SCUBAPRO[®]

Technical Service Reference & Repair Guide

Mk 15 First Stage

SCUBAPRO ENGINEERING BULLETIN #234A

SCUBAPRO® Mark 15 First Stage Piston & HP Seat Components

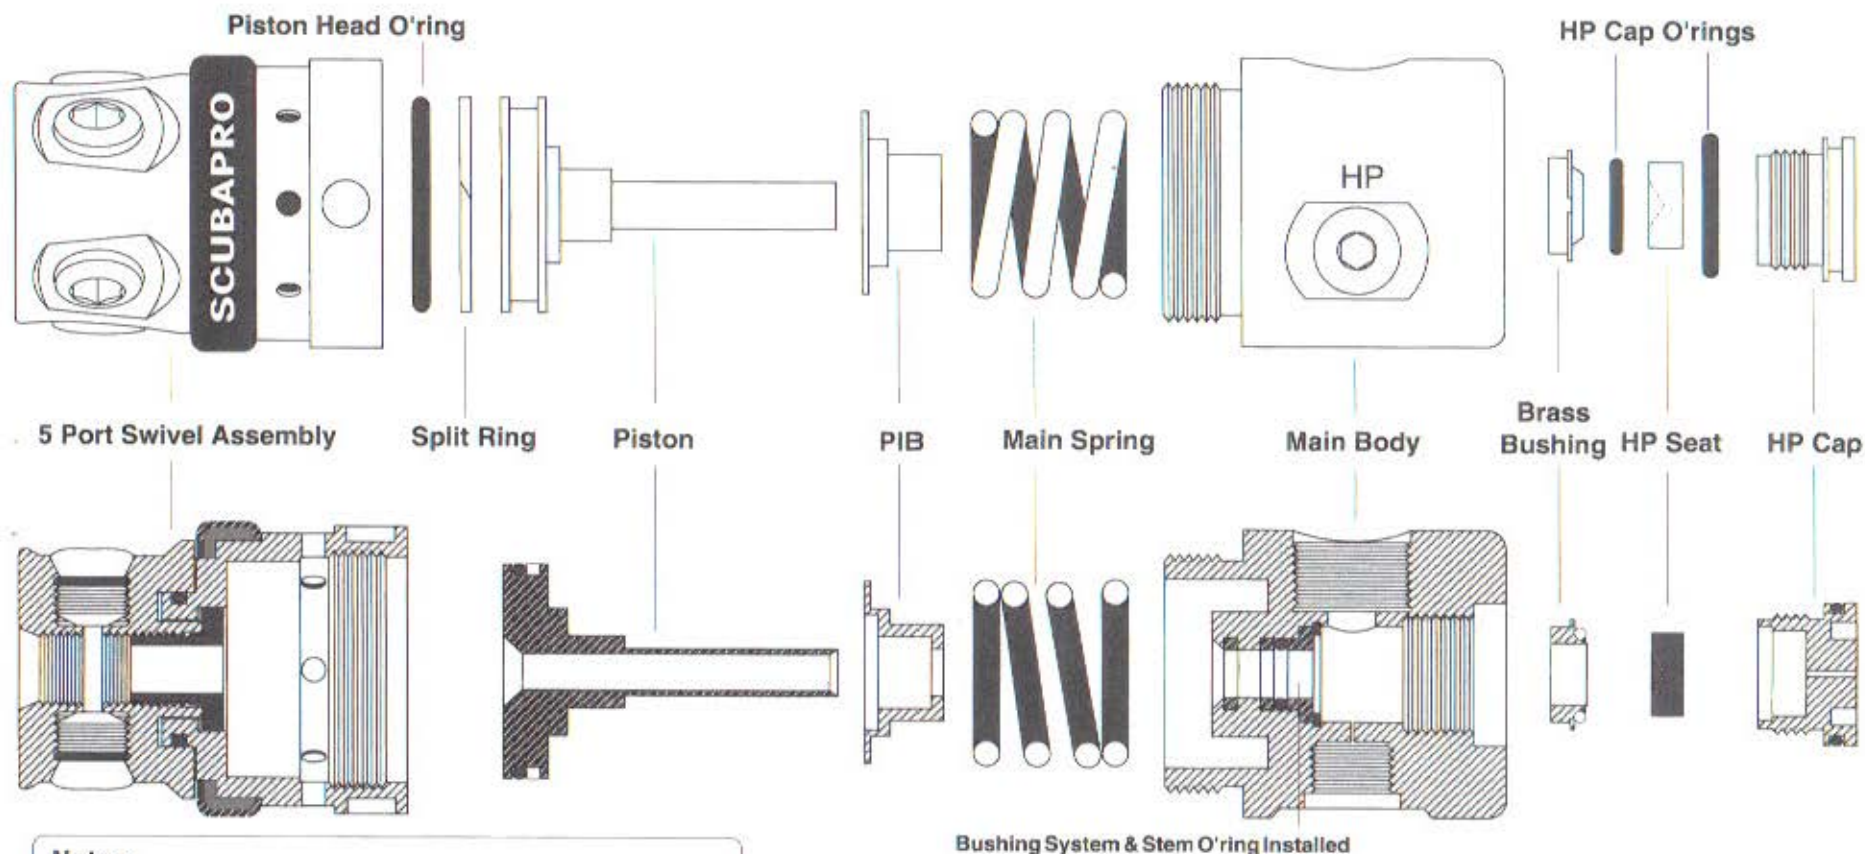
The components to the right are the original HP seat components used in the Mark 15 first stage. These were downgraded to 3000 psi. Replace with the components shown in the main illustration at the service interval.

The illustration above shows the piston and high pressure seat components. The swivel o-ring, piston head o-ring, piston stem o-ring, HP seat, and rear bushing system should be replaced during annual service. The PIB should be packed to the piston with silicone grease to prevent water exchange in this area. Lubricate all dynamic o-rings using the proper procedure. Be sure to stay up-to-date on the latest engineering information regarding HP seats available as replacement parts.

**Mark 15 Upgrade
Assembly**

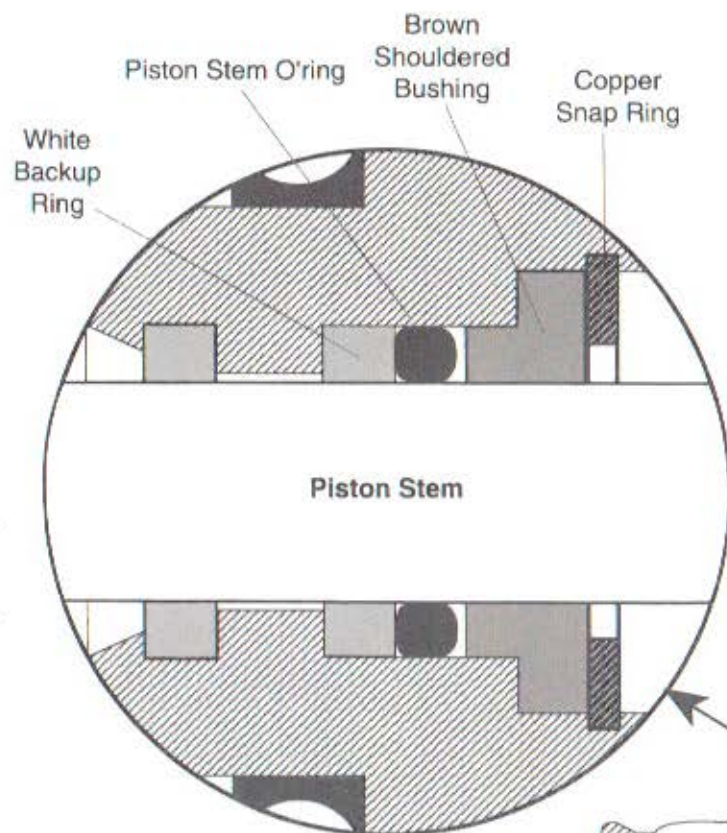
The 4350 psi bushing system consists of three parts: the white backup ring, the piston stem o-ring, and the brown shouldered bushing. These parts must be installed in the order and orientation shown. The copper beryllium snap ring retains these parts in the main body. Be sure to chase the snap ring with the Mark 15 bushing tool after it is installed to be certain that it is completely seated in the groove.

Figure #4

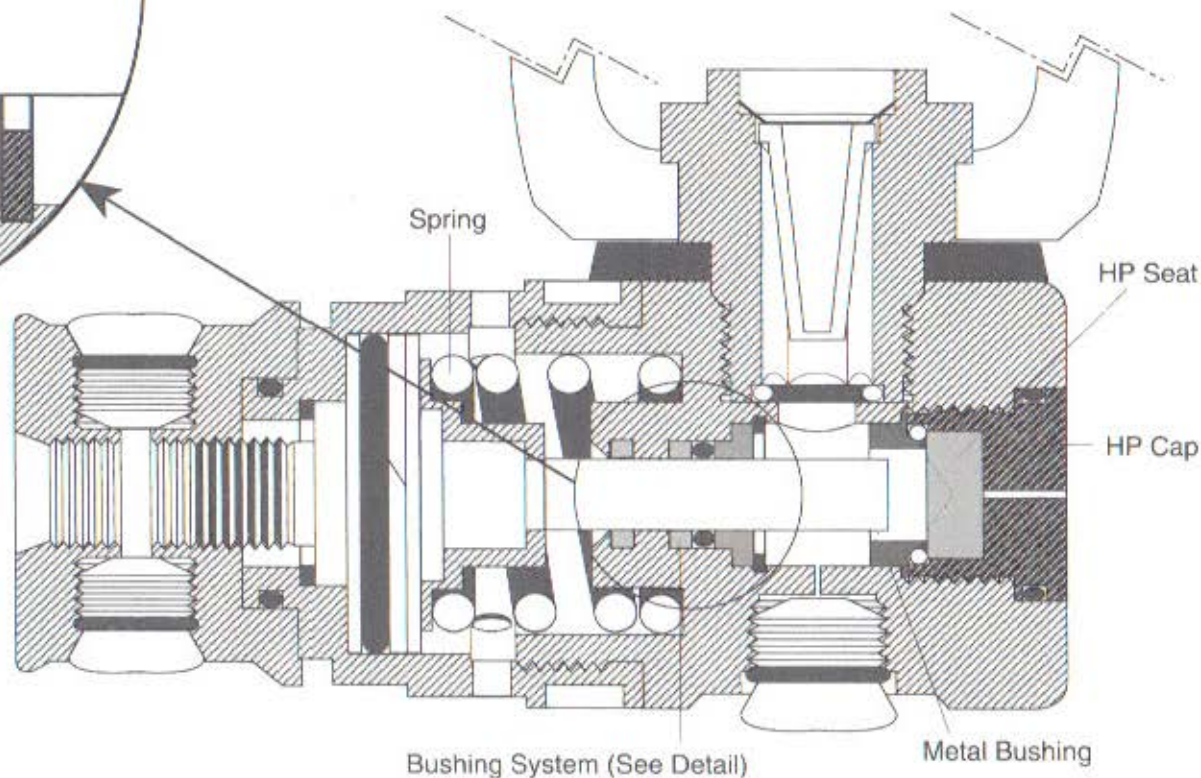
The detail above shows the Mark 15 bushing system installed inside the main body. Be sure that the piston stem o-ring is adequately lubricated to dynamic standards and the snap ring is fully seated in the main body groove. Always use a piston bullet when installing the piston into the main body to avoid damaging the piston stem o-ring.

MK 15 HIGH PRESSURE SEAT UPGRADE KIT

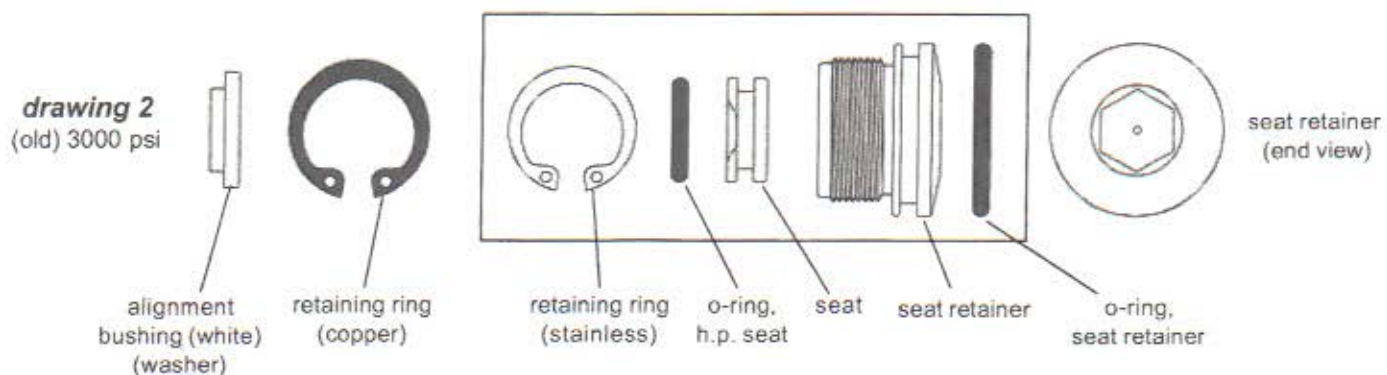
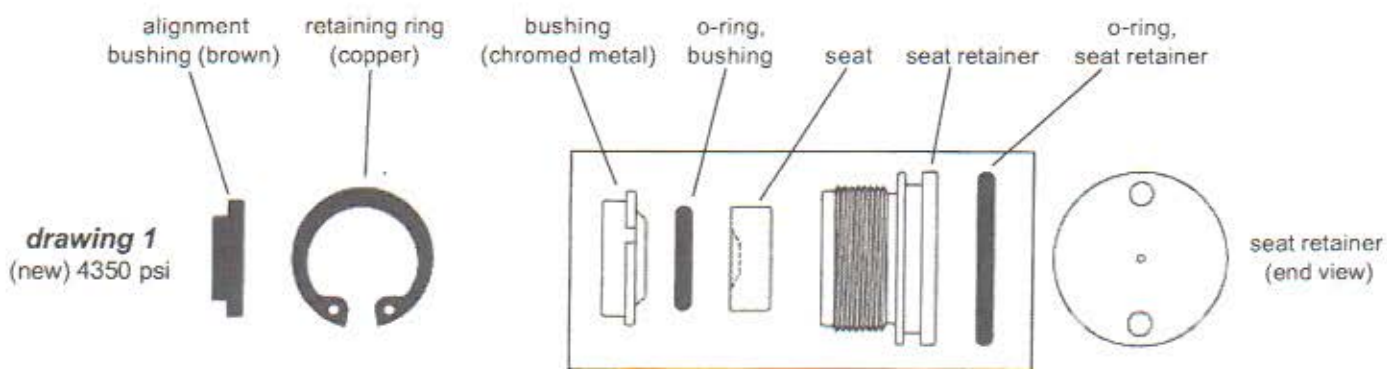
Old parts to be discarded are: see drawing #2

o-ring, seat retainer	01-050-398
seat retainer	10-600-106
seat, h.p.	10-600-122
o-ring, h.p. seat	01-050-142
retaining ring (stainless)	01-073-114
retaining ring (copper)	01-073-112
bushing (white plastic)	10-600-105
decals, 3000 psi	01-006-431

New parts are as follows: see drawing #1

o-ring, seat retainer	01-050-398
seat retainer	10-600-125
seat, h.p.	10-600-123
o-ring, bushing	01-050-401
bushing (chromed metal)	10-600-124
retaining ring (copper)	01-073-112
alignment bushing (brown plastic)	10-600-129
spring, (optional) not shown	01-020-601
